**RE:** Proposed Dredging Modifications in Cut 10

This memo is in response to EPA requests for clarification provided in Stephanie Vaughn's September 27, 2013 email

EPA Comments and CPG's response

FIGURE 1 - Coring attempts during collection of sediment samples in the RM 10.9 Removal Area (each black line indicates a coring attempt)

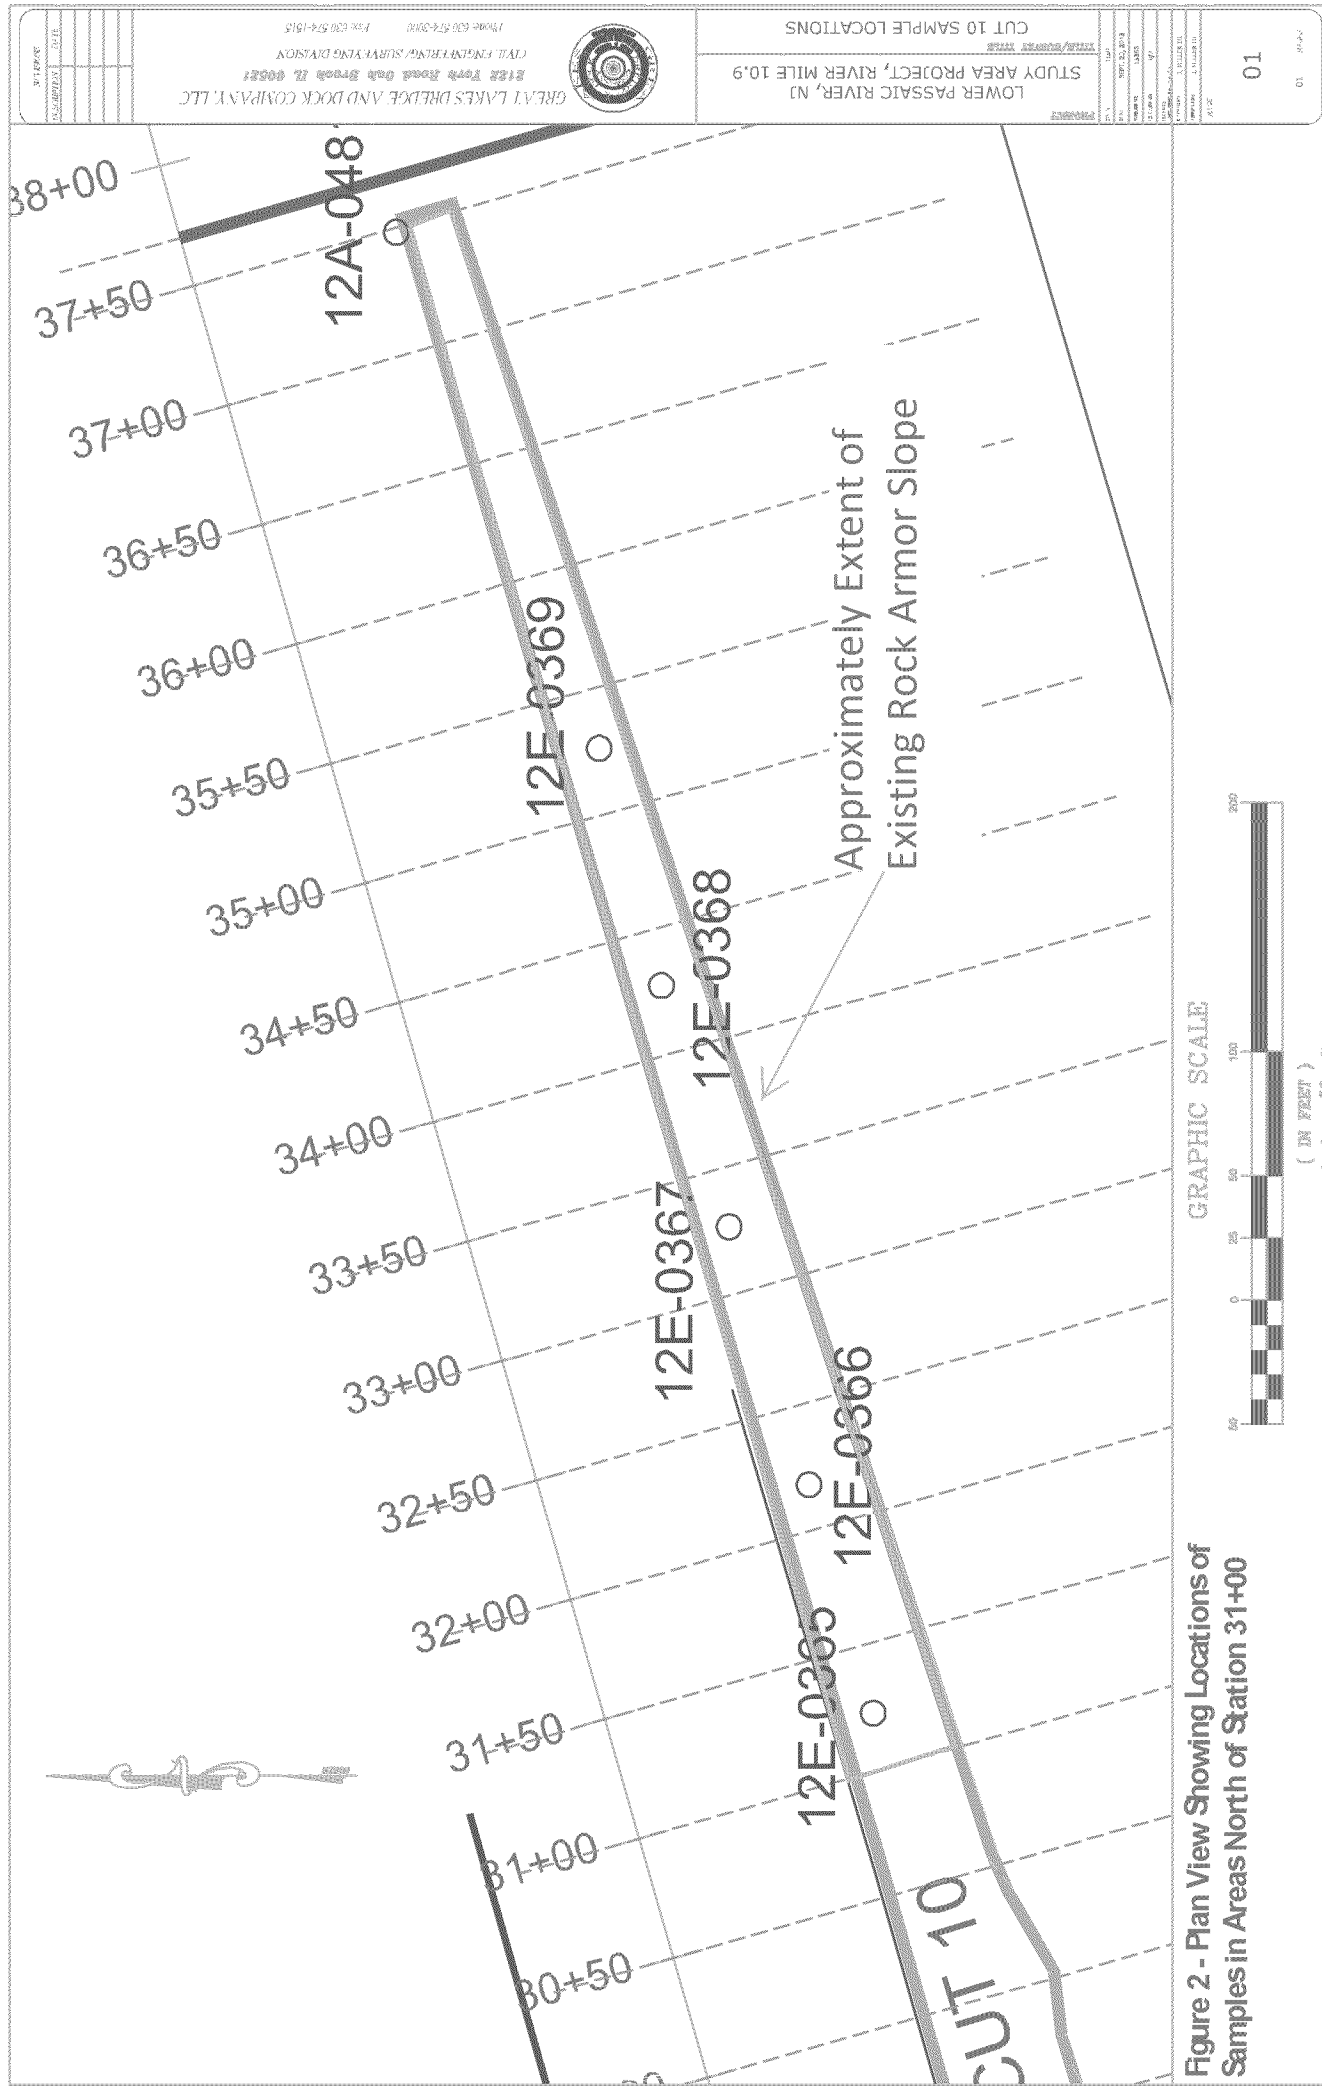
3. **Coring 0365 went down 3.5', then 0366 went down 2.5', and 0368, 0369, and 0481 went down only 1.5' before hitting refusal – this should help guide expectations.**

- a. As discussed in Item 1 above and depicted in Figure 1, many attempts were made before the above cores could even be advanced. The poling proposed for Monday afternoon should be able to demonstrate what can be dredged and what cannot be dredged.
